# Access Compliance Report

## Public Rights-of-Way

Intersection ID: 11208	Main Street: PARKWOOD_AV	Cross Street: N_BREVARD_ST	Location: NE
ADA ID: 12DB6031C5AE	Ramp Type: Perp	Initial Pass/Fail: Fail	Overall Compliance: No
Severity Score: 13.75			
Codes/Mitigation Info/Possible Solution		Field Measurements/Component Compliance

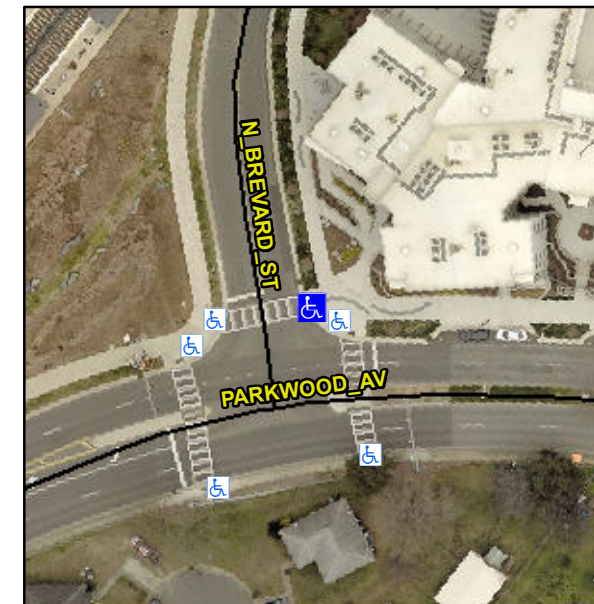
**Not Found, R304.2.2, R304.5.3**

Compliance	Description	Data	Compliance	Description	Data
N/A	Ramp Length (in)	78.0	No	Ramp Slope (%)	9.3
Yes	Ramp Width (in)	48.0	No	Ramp XSlope (%)	2.5
N/A	Flare Type LT	N/A	N/A	Flare Type RT	N/A
N/A	Flare Slope LT (%)	N/A	N/A	Flare Slope RT (%)	N/A
N/A	Flare Traversable LT?	N/A	N/A	Flare Traversable RT?	N/A
N/A	Landing Length (in)	N/A	N/A	DWS Provided?	N/A
N/A	Landing Width (in)	N/A	N/A	DWS Contrast?	N/A
N/A	Landing Slope (%)	N/A	N/A	DWS Length (in)	N/A
N/A	Landing X Slope (%)	N/A	N/A	DWS Full Width?	N/A
N/A	Landing Curb? (Y/N)	N/A	N/A	DWS Offset (in)	N/A
N/A	Shared Landing?	N/A			
N/A	Gutter Ponding?	N/A	N/A	Gutter Slope (%)	N/A
N/A	Gutter Lip Ht (in)	N/A	N/A	Gutter X Slope (%)	N/A
N/A	Painted X Walk1?	Yes	N/A	Painted X Walk2?	N/A
	X Walk 1 Direction	To W		X Walk 2 Direction	N/A
N/A	X Walk 1 Width (in)	113.0	N/A	X Walk 2 Width (in)	N/A
	X Walk 1 Slope (%)	1.7		X Walk 2 Slope (%)	N/A
	X Walk 1 X Slope (%)	1.7		X Walk 2 X Slope (%)	N/A

N/A	Ramp inside XWalk1?	Yes	N/A	Ramp inside XWalk2?	N/A
	Road Slope (%)	N/A	N/A	Clear Space?	N/A
	Road X Slope (%)	N/A	N/A	Clear Space to XWalk (in)	N/A
N/A	Any Obstructions?	N/A	N/A	Storm Grate/Utility Hazard?	N/A
	Obstruction Type			Storm Grate/Utility Type	
		N/A			N/A
		Yes		Surface Condition? (G/P)	Good

**Remove & Replace Entire Ramp.**
